APPENDIX A
INTRAAGENCY CORRESPONDENCE

SUBJECT: Outline of Proposed Planning Procedures for Proposed "Lake Pontchartrain, La. and Vicinity," Project

LAKE PONTCHARTRAIN, LA AND VICINITY
 LAKE PONTCHARTRAIN BARRIER PLAN
 DESIGN MEMORANDUM NO. 2 - GENERAL DESIGN
 CITRUS BACK LEVEE
 IHNC THRU NASA
 I-WALL DESIGN ANALYSIS
 U.S. ARMY ENGINEER DISTRICT, NEW ORLEANS
 CORPS OF ENGINEERS
 AUGUST 1967 FILE NO. H-2-23908

PLATE 1

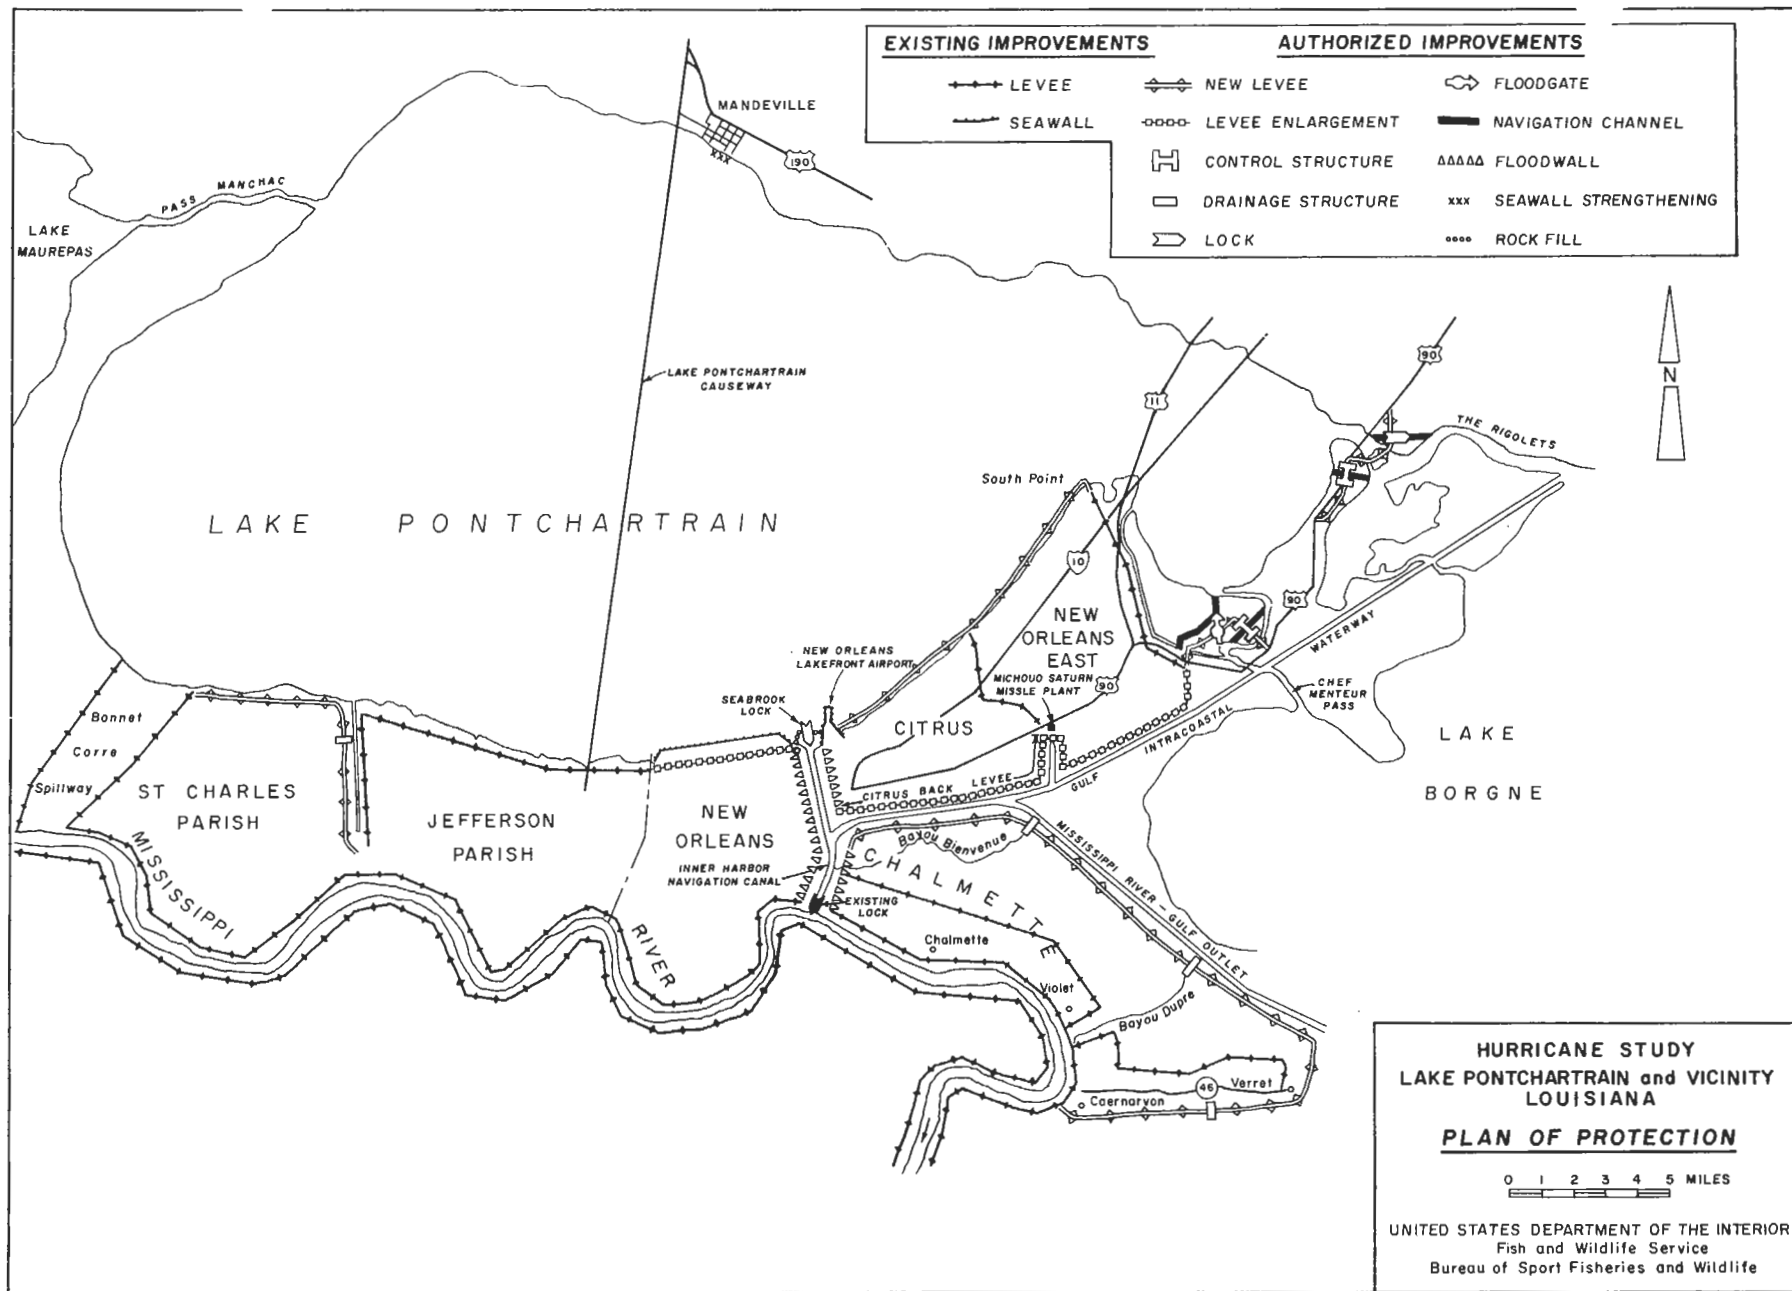
You requested in your letter of April 21, 1967, that we comment specifically on the Citrus back levee alignment (plate 1). Citrus back levee enlargement extends along the north bank of the Gulf Intracoastal Waterway from the Inner Harbor Navigation Canal to the proximity of the Michoud Saturn Missile Plant. Because of the rapidly expanding industrialization of this area, your plan to enlarge this existing levee segment will have very little, if any, adverse influence on fish and wildlife resources in the project study area.

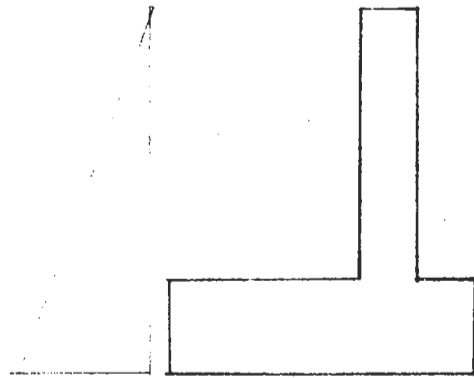
Does not agree with
calculations or sketch on D-21

FIGURE D-42

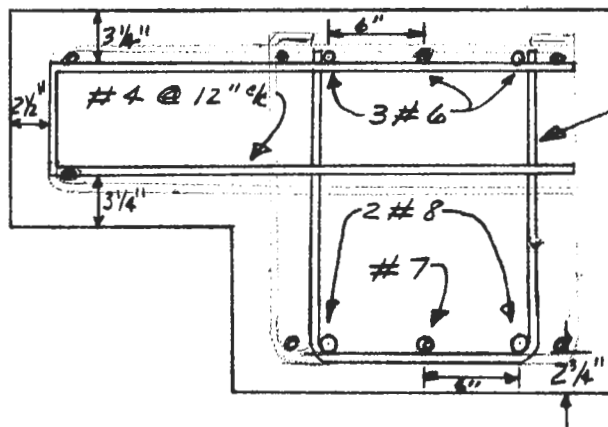
Suggest 2 1/2" COVER
OVER MAIN BARS
all around
